The Hanna Furnace Corporation  
Solid Waste Management Facility  
Engineering Report  
Addenda #1

March 4, 1980

3.4 Operations Map:

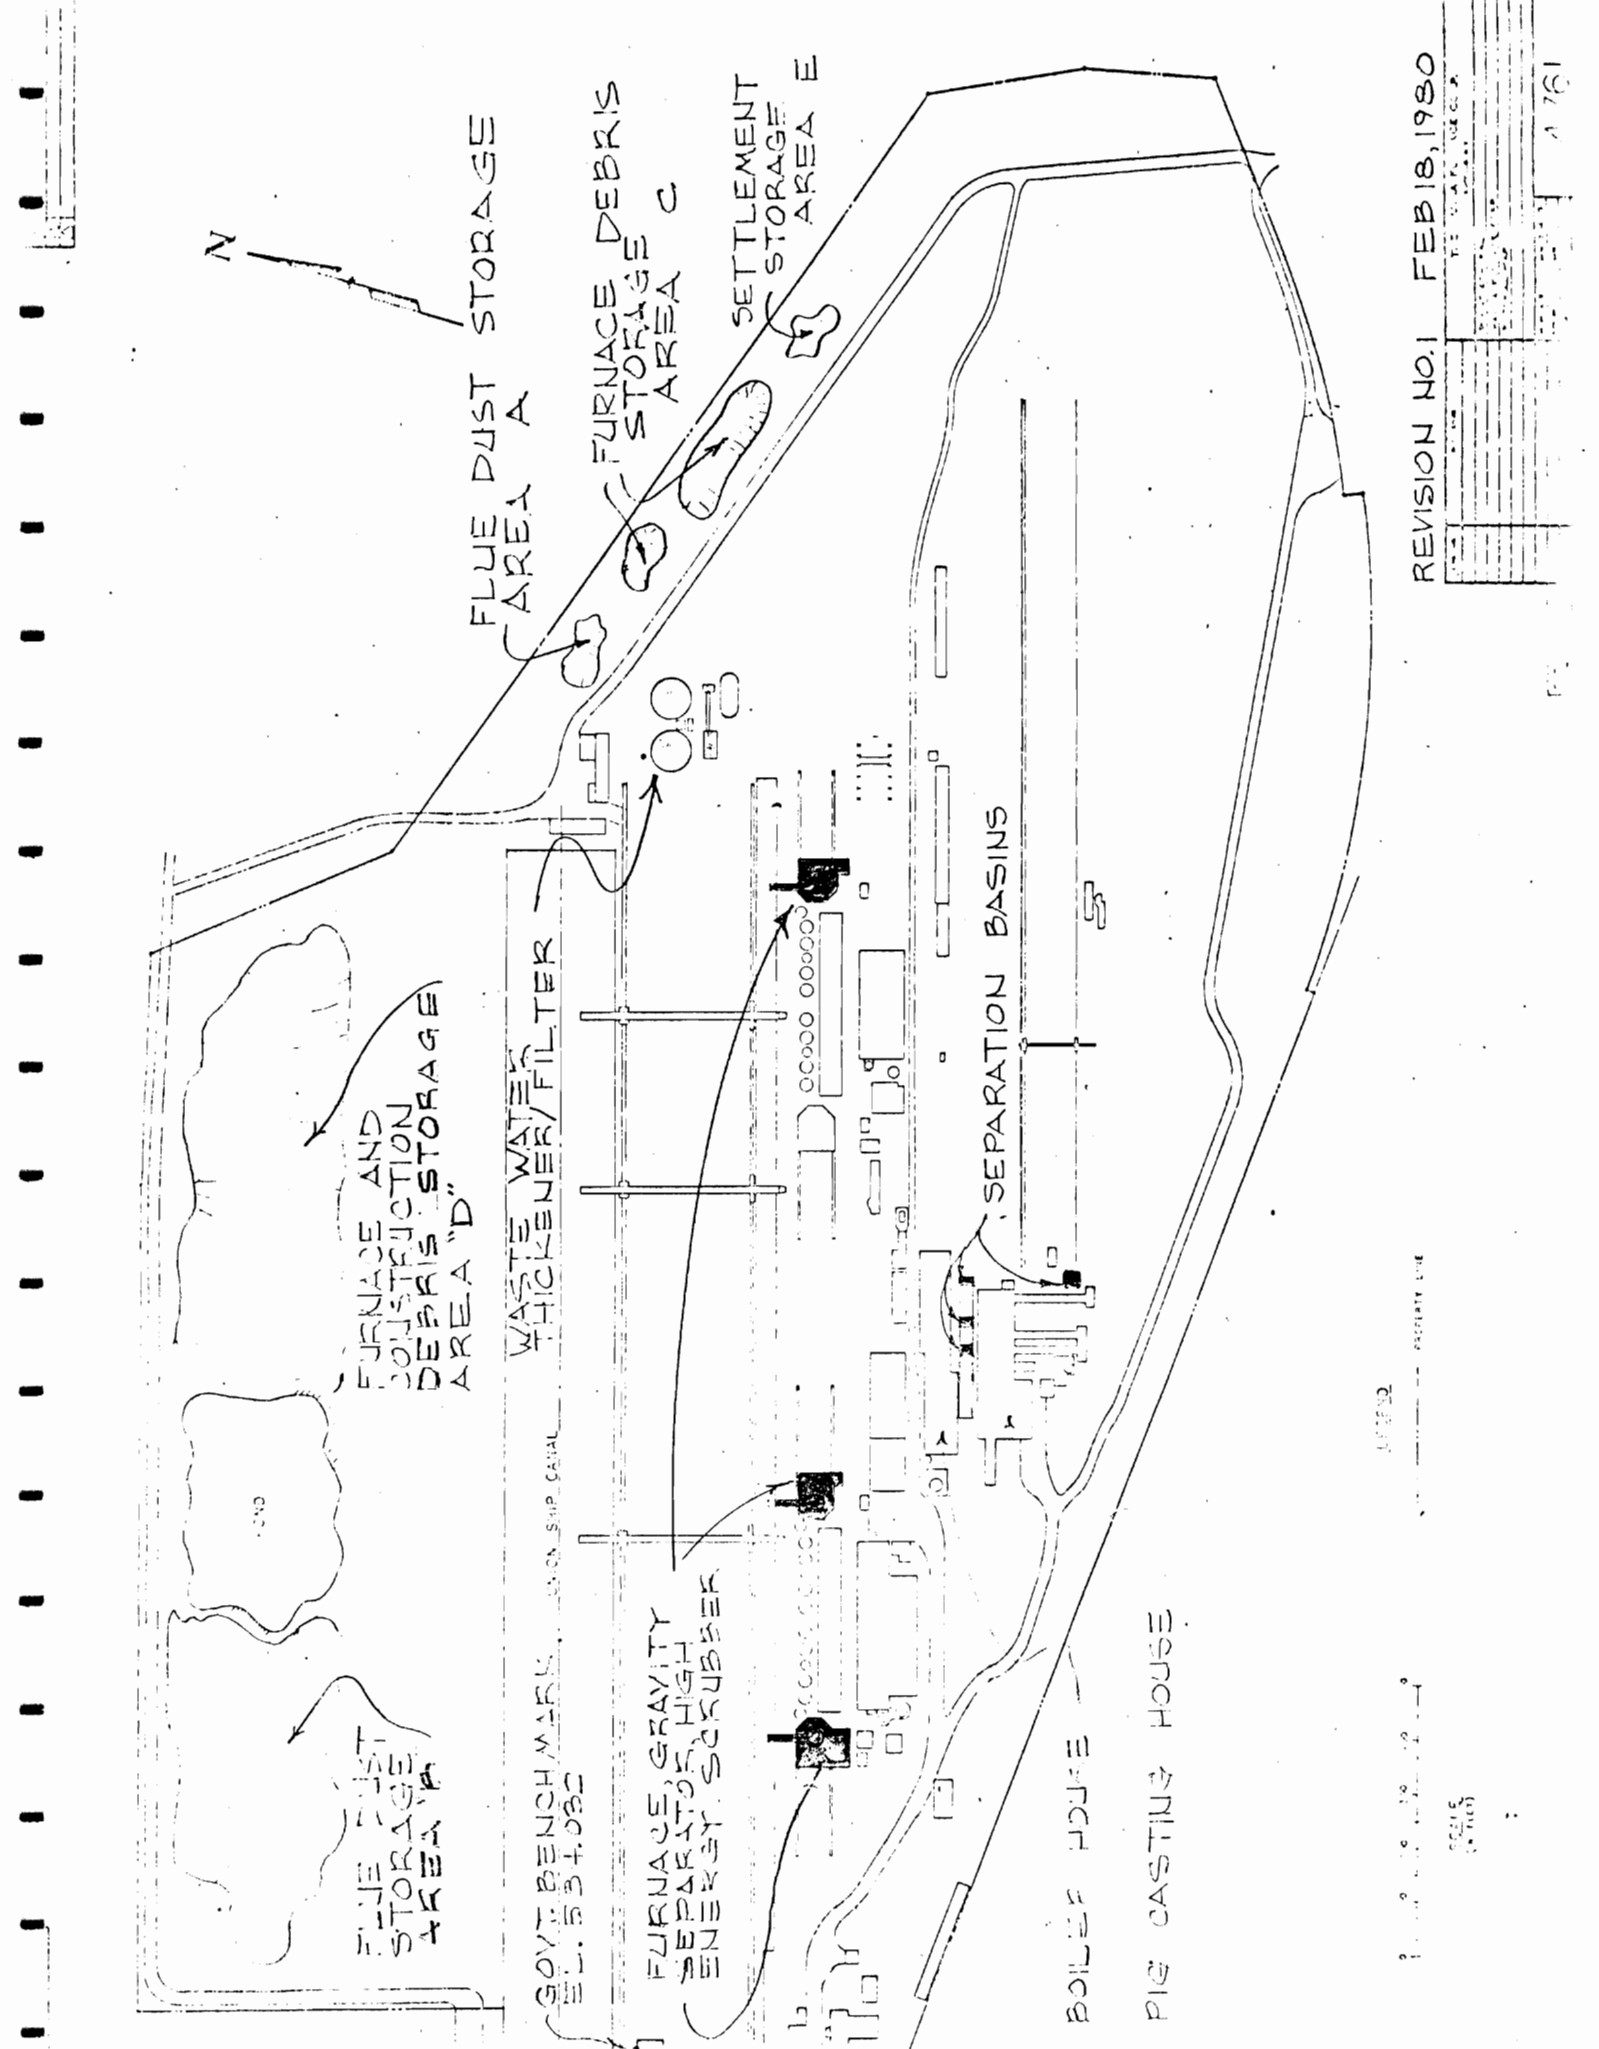
- a.) Attached find revised operations map locating the settlement basins and "Settlement Storage Area E"
